SERVICE BULLETIN

M-943

February 27, 1987

5-SPEED TRANSMISSION GEAR CHANGE

Figure 1. Old and New 5th Gears, Countershaft

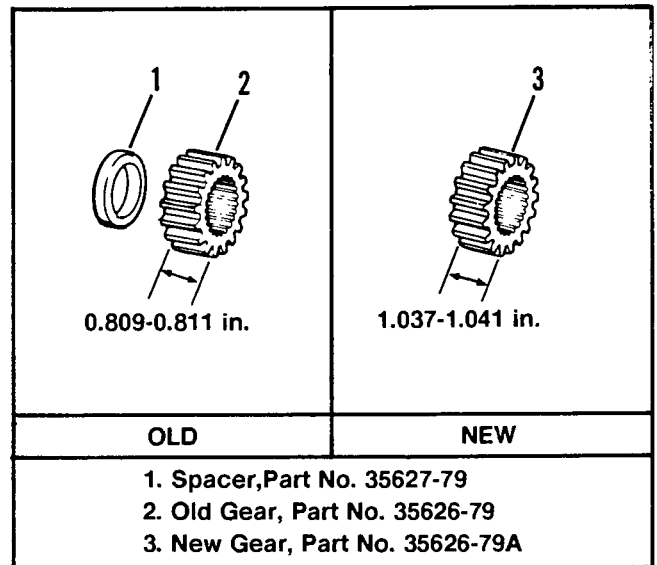
See Figure 1. The new gear, Part No. 35626-79A has been increased in width, eliminating the need for Spacer, Part No. 35627-79. To identify whether a gear is "old" or "new" measure the gear width and compare the measurement with those given in Figure 1.

If "old" gear, Part No. 35626-79 or Spacer, Part No. 35627-79 are ordered, the new gear will be sent. Part Nos. 35626-79 and 35627-79 are obsolete.

Removal and installation of the new gear is covered in the applicable Service Manual; except, DO NOT use Spacer with new gear.
